**STAFF RECOMMENDATION**

**1506 Shelby Avenue**

**June 20, 2018**

**Description of Project:** Application is to change the flat roof of an existing outbuilding to create a gabled roof.

**Figure 2: 1506 Shelby Avenue site plan (addition to the primary structure has been constructed).**

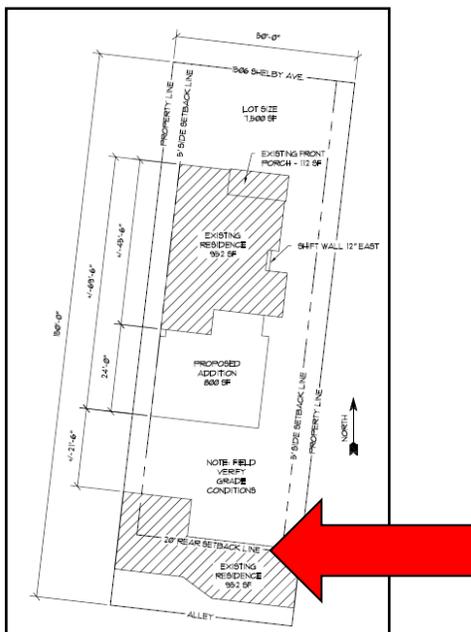
The outbuilding is approximately nine hundred and fifty-two square feet (952 sq ft) and does not meet the current setback requirements and is larger than what would typically be allowed. Because the proposed work is not changing the footprint, increasing the square footage or adding an additional level and because the pitched roof will bring the building more into compliance with the design guidelines, the project meets the design guidelines.

Figure 3: 1506 Shelby Avenue existing outbuilding from alley. Arrow indicates roof peak of main house, beyond.

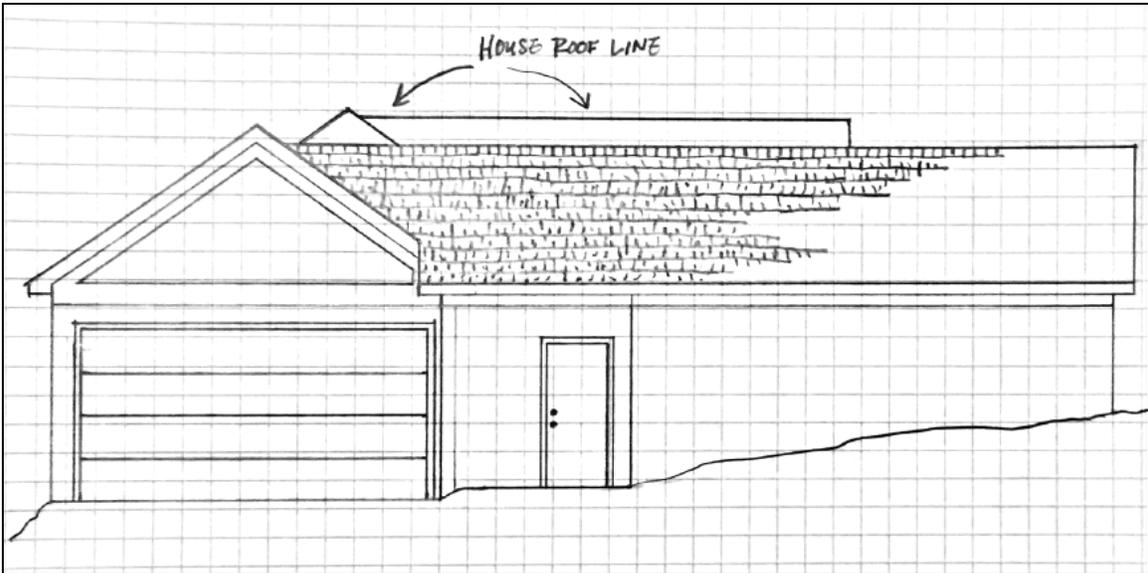
The roof form and slope are similar to historic outbuildings. Staff finds that the project meets Section II.B.8.a of the design guidelines.

The pitched roof will allow the owner the headspace to park a van in the garage. This accessory structure has a simple, utilitarian design that is appropriate for outbuildings. Changing the roof will alter the form, but it will not make the design inappropriate for an outbuilding. The roof form, detailing, and form do not and will not contrast greatly with the primary structure. The fenestration is limited to the interior elevation, is simple and does not contrast greatly with the neighborhood context.

**Figure 5: rear of house on right and rear of existing outbuilding on left.**

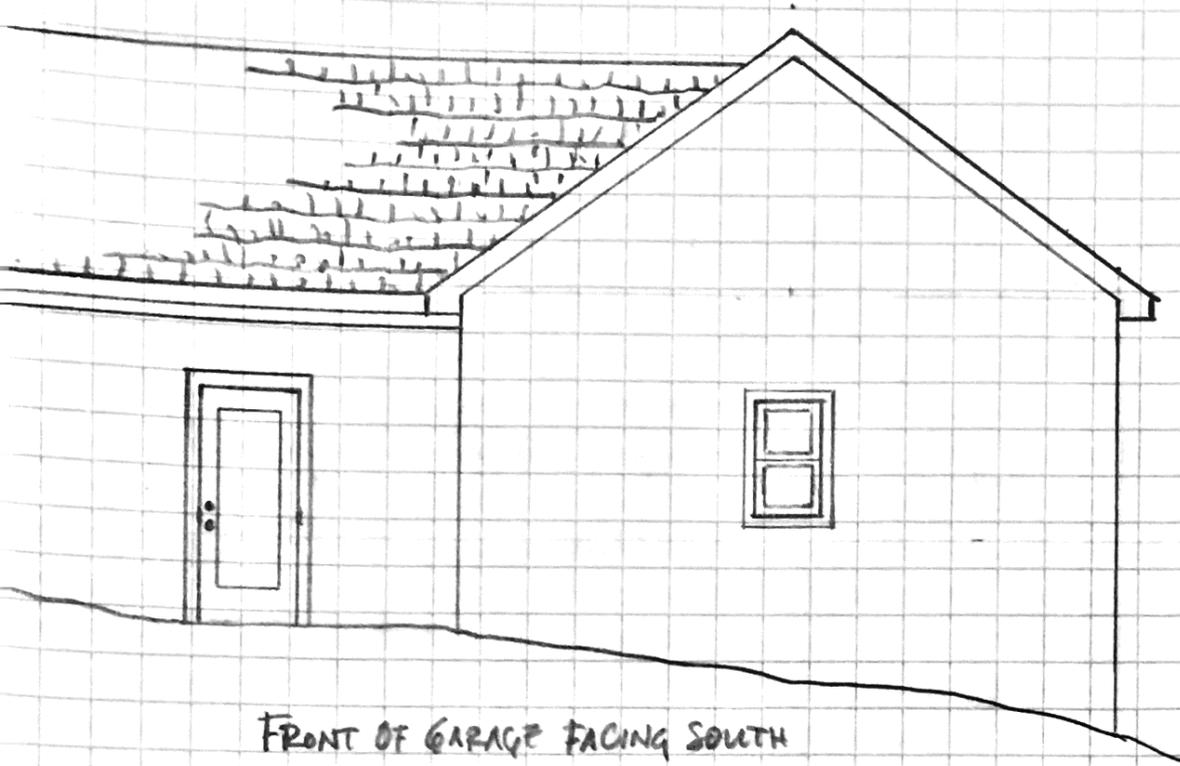
The altered roofline as proposed will continue to meet the guidelines for height, being approximately sixteen feet (16') high with an average eave height of about eight feet (8'). The building is about nine hundred and fifty-two (952) square feet, which is over the seven hundred and fifty square feet (750 sq ft) that is allowed, however, this is an existing condition and the proposed changes will bring the building more into compliance.
